ONSITE SEWAGE DISPOSAL SYSTEM

PROPERTY ADDRESS: 5313 Broadwater Lane

ONSITE SEWAGE DISPOSAL SYSTEM DESIGN PLAN for #5313 BROADWATER LANE
 (RECORDED AMONG THE LAND RECORDS OF HOWARD COUNTY, MARYLAND IN DEED: W.A.R. 17849/316)
 #5313 BROADWATER LANE
 5-TH ELECTION DISTRICT
 NEAR CLARKSVILLE
 HOWARD COUNTY, MARYLAND

SEPTIC SYSTEM PROFILE (#5313 BROADWATER LANE)

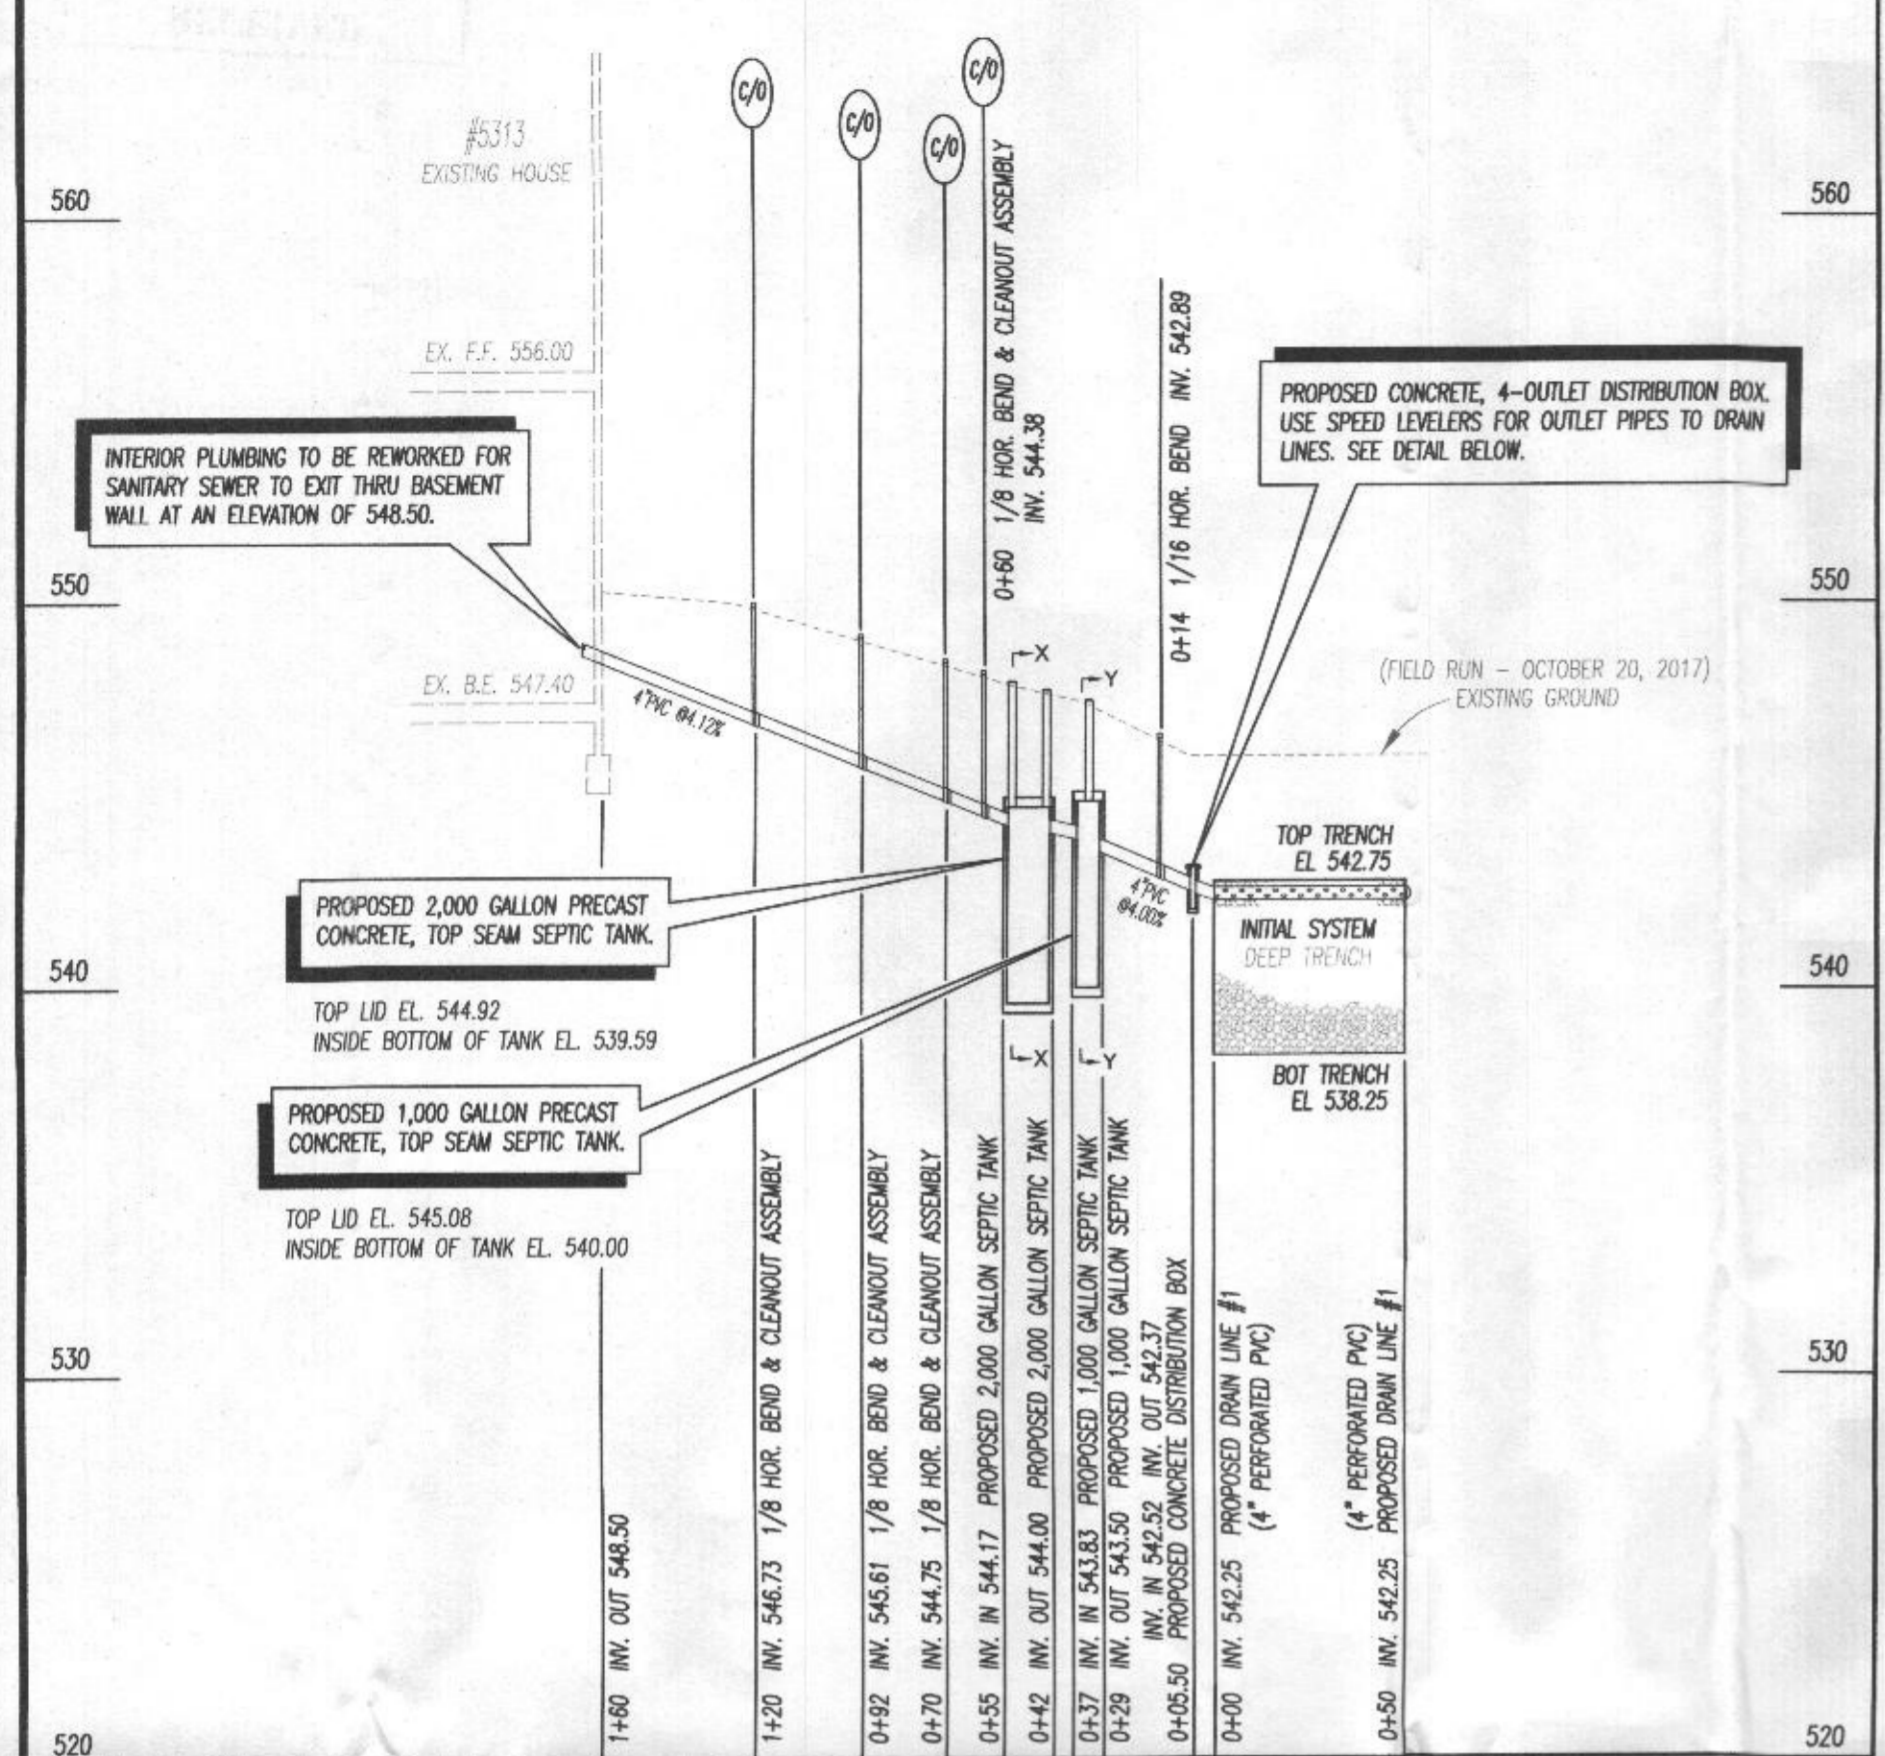
Attached please find an As-Built survey of the sewage disposal system, partially installed, for the above referenced property. The "As-Built" locations are depicted in red on the attachment. Based on the survey, the existing system, at its terminus, is about 2 feet lower than the plan grades called for.

I don't know if you would allow us to lower the bottom elevation of the deep trench system, that was originally designed, to compensate for the unusually deep sewer line on this property.
Please Advise.

If not, the depth of stone in the primary sewage disposal system could be reduced by two feet and still accommodate an eleven bedroom Assisted Living Facility, with 3 full time staff members. I have attached sewerage calculations below. Such a revision would still allow gravity flow to the primary and two replacement systems.

After reviewing this project and where we are right now, the Health Department cannot allow Freedom Septic to proceed with the current septic system install. The approval of a trench inlet invert depth below 6ft is not something we condone. It poses potential issues in the future to the soil absorption system as well as the overall performance of the trenches and system functionality. Not to mention this is an unsafe practice for the installers and our inspections as we need to get in and around the trench to inspect.

From here, you will need to either have the plumbing at the house re-designed with an ejector pit in the basement so that the plumbing is a workable depth with an ejector pit in the basement or revise the current OSDS plan to show a pump system adequate enough to support the design flow we have. Please note the septic tanks that were set in the ground yesterday would have to be relocated to meet a less than 4ft of earth cover depth to grade. We tried to come up with a solution yesterday afternoon in the field but nothing that could be approvable.

Can we grade over the septic tank (cut of 3 feet) and effluent area (maximum cut of 2 feet) to remedy this situation?

I have attached a grading plan which depicts this grading. Given percolation testing results, I do not believe that we would be harming the effluent area with this minimal amount of cut. In an effort to mitigate costs for my client, I would like to know if this is an option. Please advise.

That would be theoretically possible. I can think of a dozen reasons why it could end up not working. You would have to start with a proposed grading plan to see what you would need to do to get that soil off without disturbing the SDA, leaving the tank in a swale, or directing drainage to the SDA. After that, there would be all the different ways it could go wrong, e.g. failed percs, different perc rates, etc. This would also be a course of action that would probably take a month or more to complete.

You can't grade over the sewage disposal area either by adding fill or cutting away for a variety of reasons. It is possible to adjust grading over a tank to get the desired amount of cover, but I'm not sure you'll be able to do that here with the proximity to the SDA that can't be graded without ending up with the tank in a graded swale of some sort, or creating excess drainage onto the SDA, which is not allowed.
